Ornob Fashion Wear Ltd

25th March 2015

Observations

Cracking in column, wall and roof connection - (Shed 6)

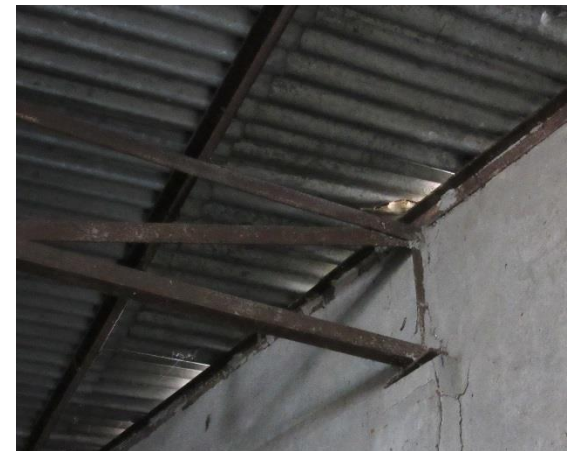
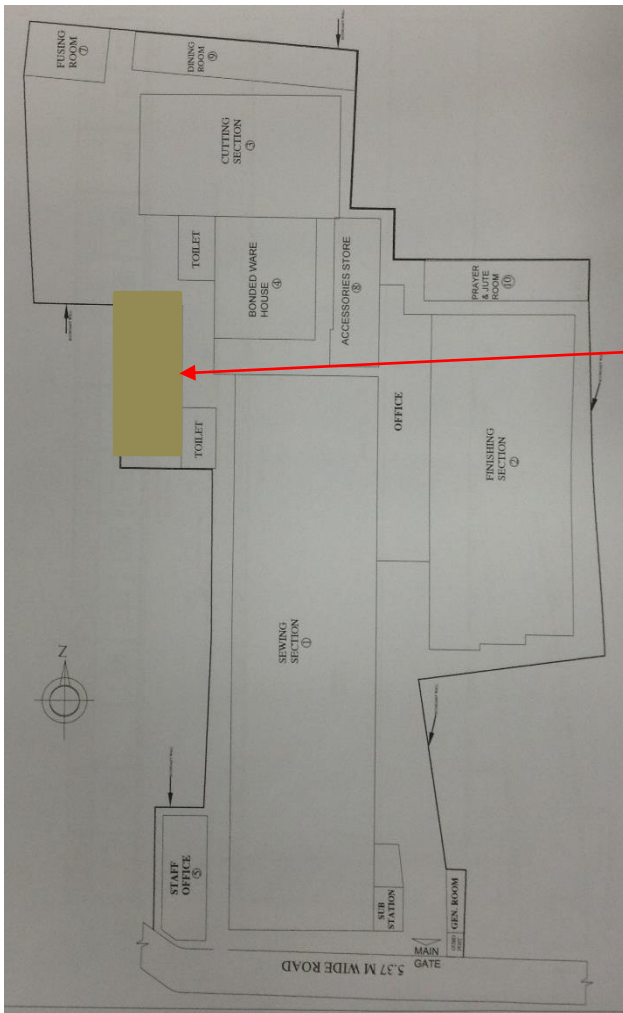
Corroded steel roof structure - (Shed 6)

Roof steel beams structure appears to be corroded.

Item No.	Observation	Recommended Action Plan	Recommended Timeline
1	Cracking in column, wall and roof connection - (Shed 6)	Building Engineer to investigate the possible reasons of the crack, top of column and the roof connections.	6-weeks
2	Cracking in column, wall and roof connection - (Shed 6)	Carry out any remedial structural works arising from the investigation.	6-months
3	Corroded steel roof structure - (Shed 6)	Building Engineer to investigate the degree of corrosion and the capacity of the corroded structure.	6-weeks
4	Corroded steel roof structure - (Shed 6)	Connections of the roof structure to the vertical load bearing elements to be verified for conformity.	6-weeks
5	Corroded steel roof structure - (Shed 6)	Carry out any remedial structural works arising from the investigation.	6-months
6	Apparently non-engineered roof structures (all sheds)	Building engineer to survey and investigate the roof structures of all sheds and to ensure adequacy for code vertical and horizontal loads including wind and up-lift.	6-months

Possible lack of lateral bracing for the steel roofs of all the sheds

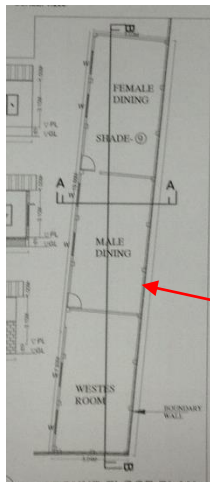
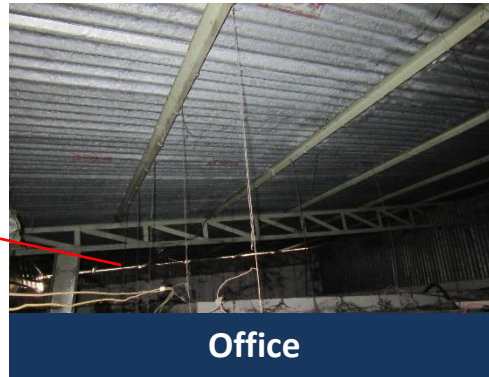
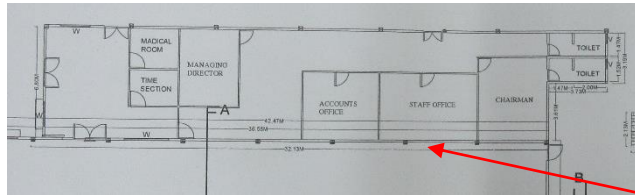
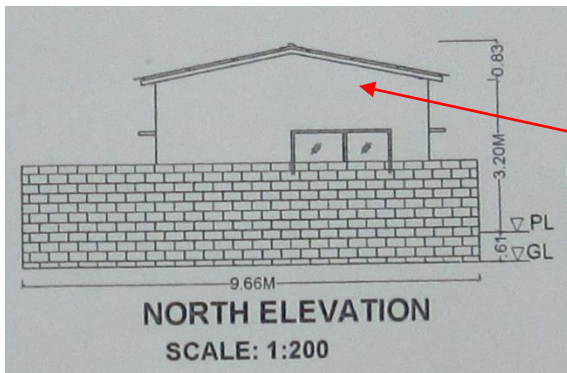
Lateral stability system non-apparent:

Generally:

- No bracing
- No moment frame
- Non-load-bearing brick walls as in-fill on perimeter lines (exception is shed 6 which consists of metal sheet cladding)

Lateral stability system of sheds is non-apparent

Item No.	Observation	Recommended Action Plan	Recommended Timeline
9	Possible lack of lateral bracing for the steel roofs of the shades	The Building Engineer to investigate the lateral longitudinal stability and bracing of all the buildings. Code adequacy to be ensured and eventual alterations to be defined.	6-months
10	Possible lack of lateral bracing for the steel roofs of the shades	Make any structural alterations as advised by Factory Engineer.	6-months
11	Discrepancies between permit/structural/architectural drawings and as-built structure	Building engineer to survey as constructed building. Updated drawings to be prepared showing the correct as constructed layouts, roof structures and shed 11 (Office building).	6-months
12	Apparently non-engineered Water towers	Building engineer to survey and investigate the structures of the water towers. Adequacy for code vertical and wind loads to be ensured	6-months

Apparently non-engineered Water towers

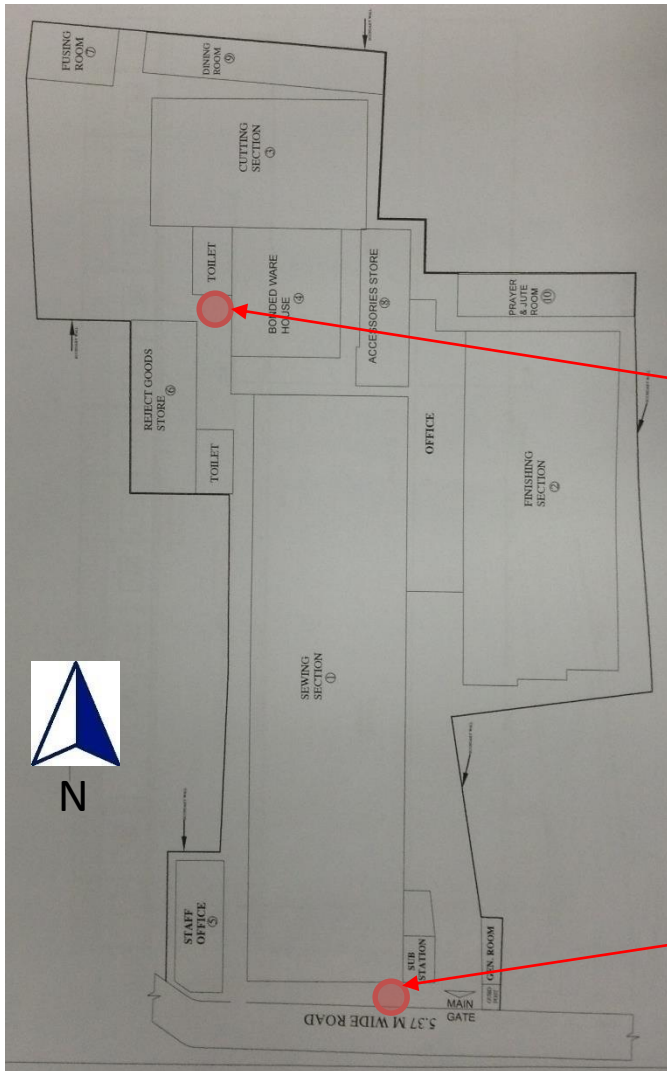
Water towers in two locations appear to be non-engineered.

13	Apparently non-engineered Water towers	Perform any structural alterations as advised by Factory Engineer.	6-months
14	Apparently non-engineered lightweight roof between Shed 7 and Shed 9	Lightweight bamboo roof is to be reconstructed/upgraded to ensure adequacy for code vertical and wind loads by the Building Engineer.	6-months
15	Apparently non-engineered lightweight roof between Shed 7 and Shed 9	Perform any structural alterations as advised by Factory Engineer.	6-months

Apparently non-engineered lightweight roof between Shed 7 & 9

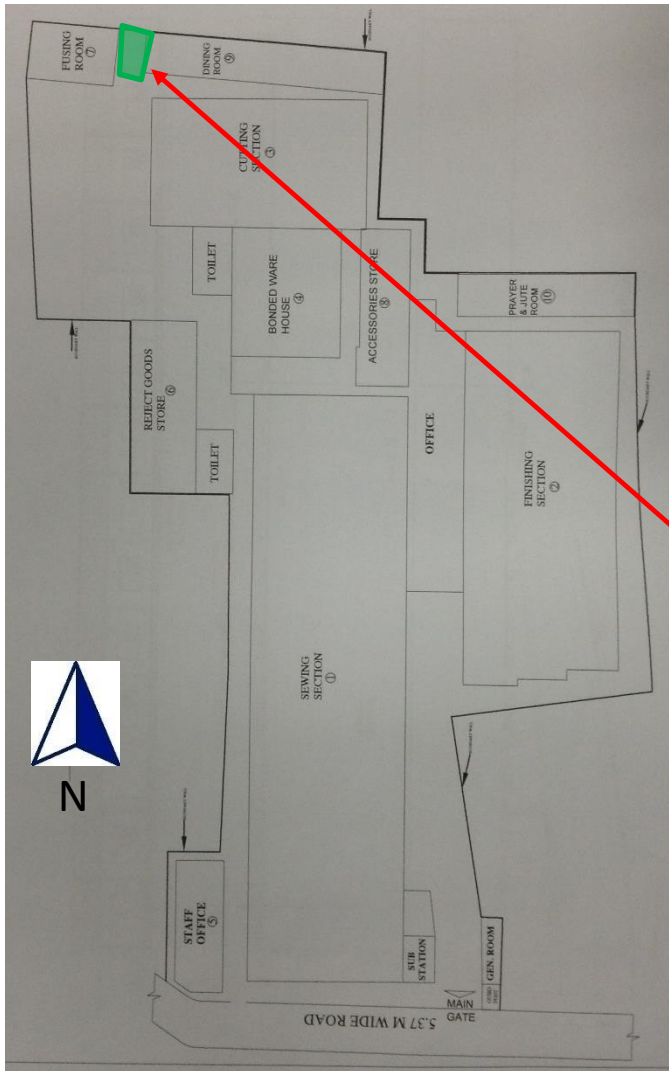
Bamboo decking between Shed 7 and Shed 9 appears to be non-engineered
